REVISION	DESCRIPTION	DATE
A	DEVELOPMENT APPLICATION	09/2020
B	DA AMENDMENTS 1. First floor plan reconfigured with the rear first floor setback increased by 2.365m to ensure compliance with the maximum 10m Building Height limit. 2. The width of the first floor balcony has been reduced and the storage area at the rear of the carport has been deleted.	03/2021

PROPOSED DWELLING HOUSE
FOR
WILLIAM & NANCY GROUNDS

ADDRESS
13 PACIFIC ROAD PALM
BEACH, NSW, 2108 LOT NO.
404 | DP NO. 19651

FIRST FLOOR PLAN
SCALE 1:100

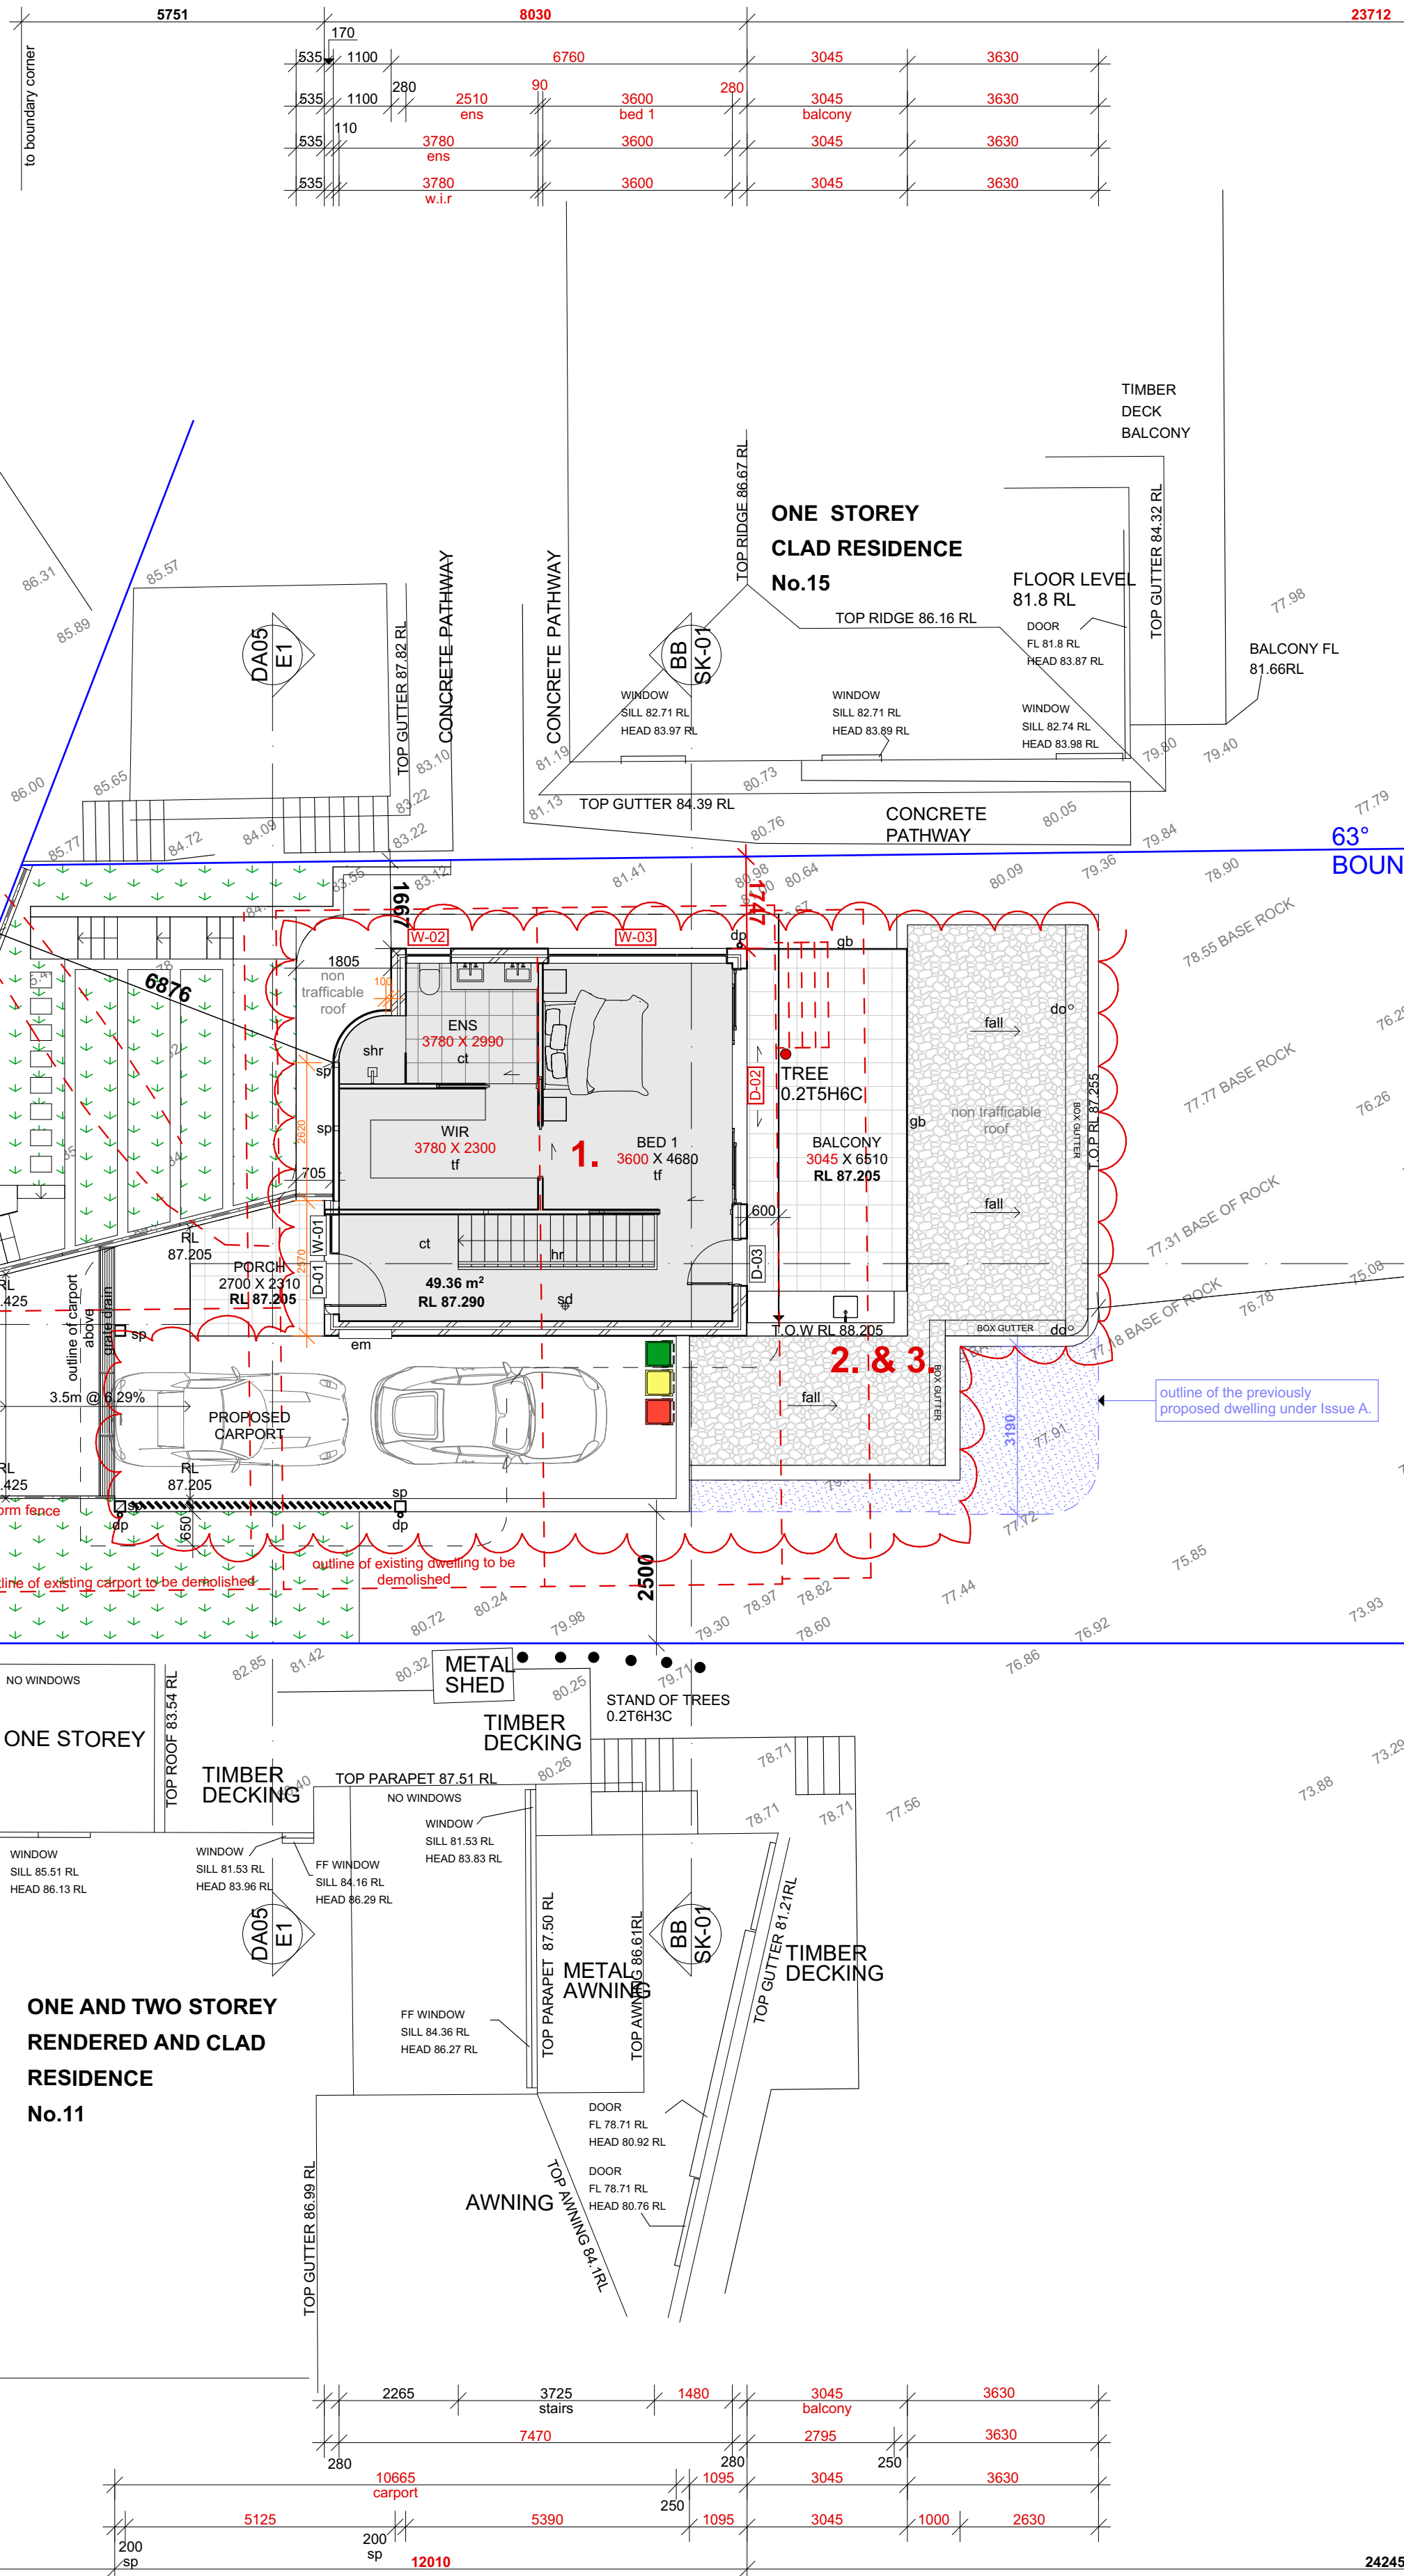
REVISION	DESCRIPTION	DATE
A	DEVELOPMENT APPLICATION	09/2020
B	DA AMENDMENTS 1. First floor plan reconfigured with the rear first floor setback increased by 2.305m to ensure compliance with the maximum 10m Building Height limit. 2. The width of the first floor balcony has been reduced and the storage area at the rear of the carport has been deleted. 3. The non trafficable portion of the first floor balcony has been removed to comply with the maximum 10m Building Height limit. 4. The carport roof over the proposed driveway has been reduced in length by 4.505m to comply with the maximum 10m Building Height limit. 5. The southern portion of the ground floor and lower ground floor balconies shown hatched on plan have been removed. 6. The ramp on the lower ground floor has been setback a further 600mm from the southern side boundary. 7. The southern external wall of the WC and Butlers Pantry on the ground floor have been aligned with the external walls above and below. 8. The southern side solid driveway has been replaced with an open form fence.	03/2021

SHADOW DIAGRAMS - JUNE 21st
1:200 SCALE

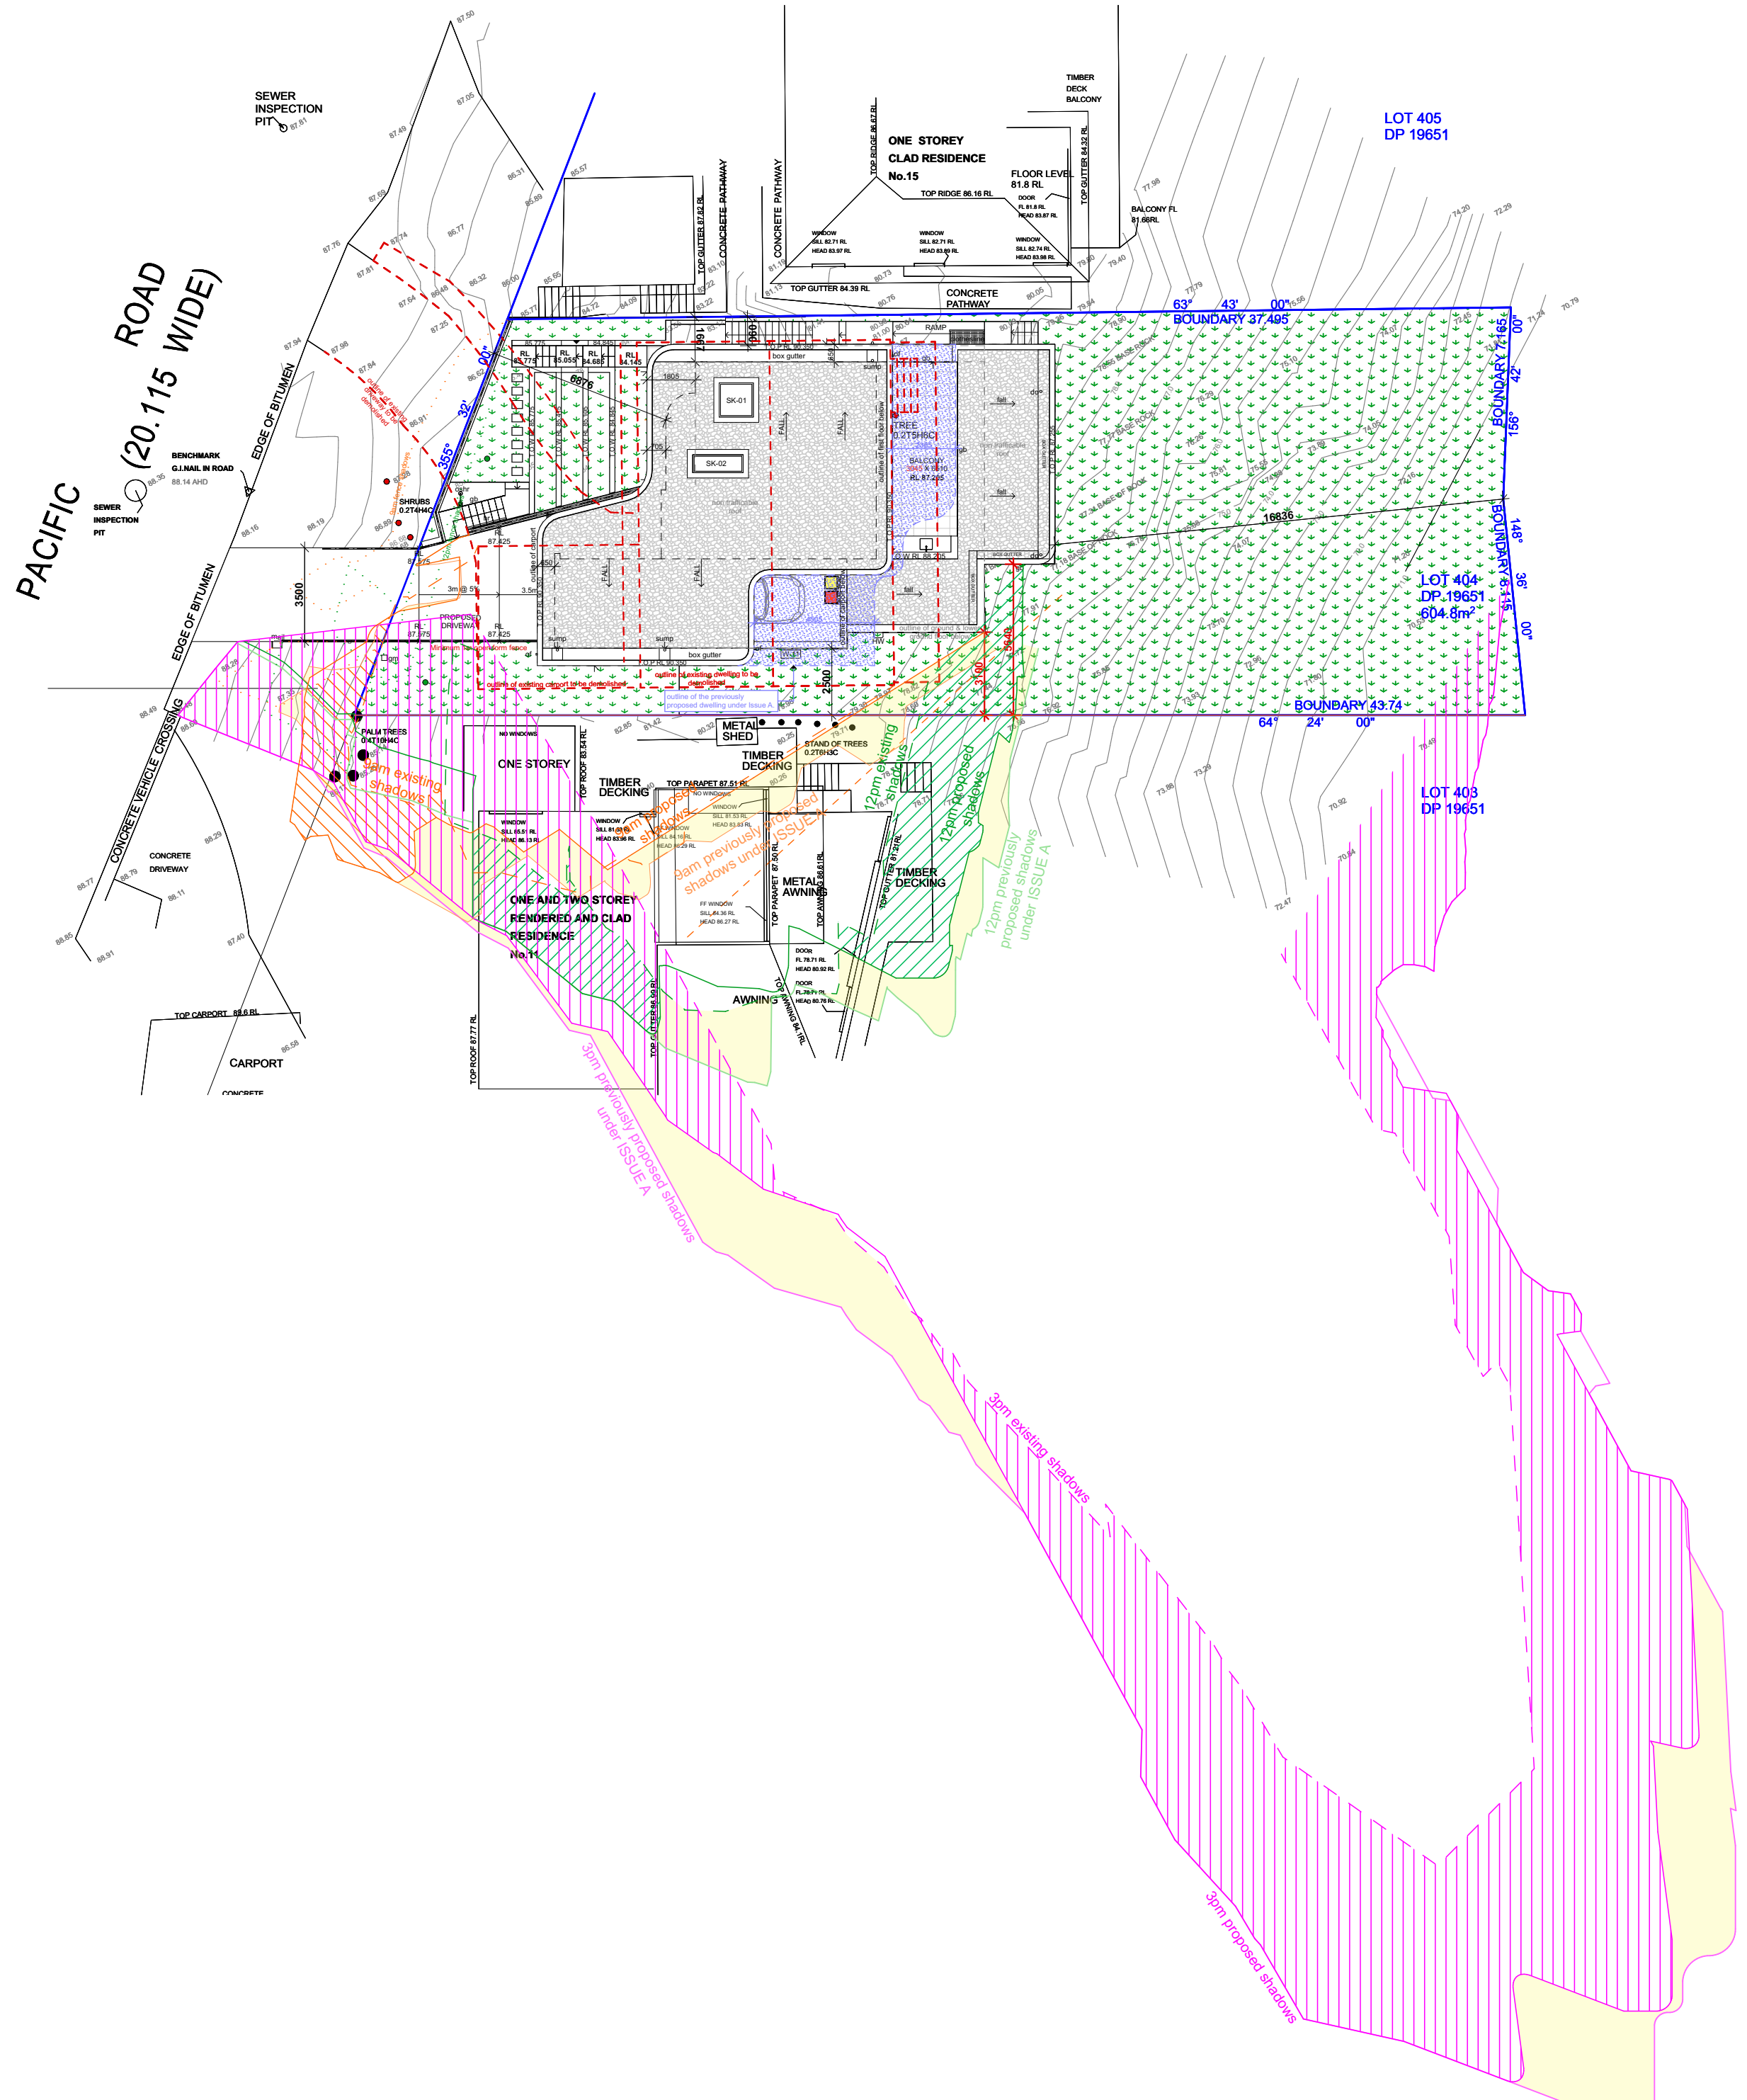
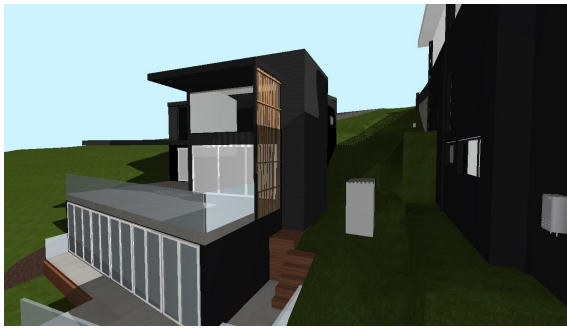
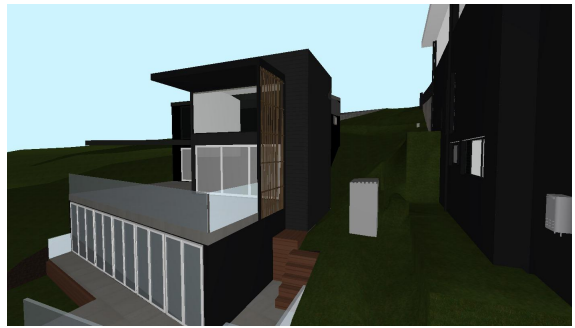
- Existing shadows
- Proposed shadows
- Fence shadows
- Extent of additional overshadowing on adjoining properties due to proposed development at 9:00am on June 21st
- Extent of additional overshadowing on adjoining properties due to proposed development at 12:00pm on June 21st
- Extent of additional overshadowing on adjoining properties due to proposed development at 3:00pm on June 21st
- Extent of additional sunlight on adjoining properties due to amendments made to the proposed development on June 21st
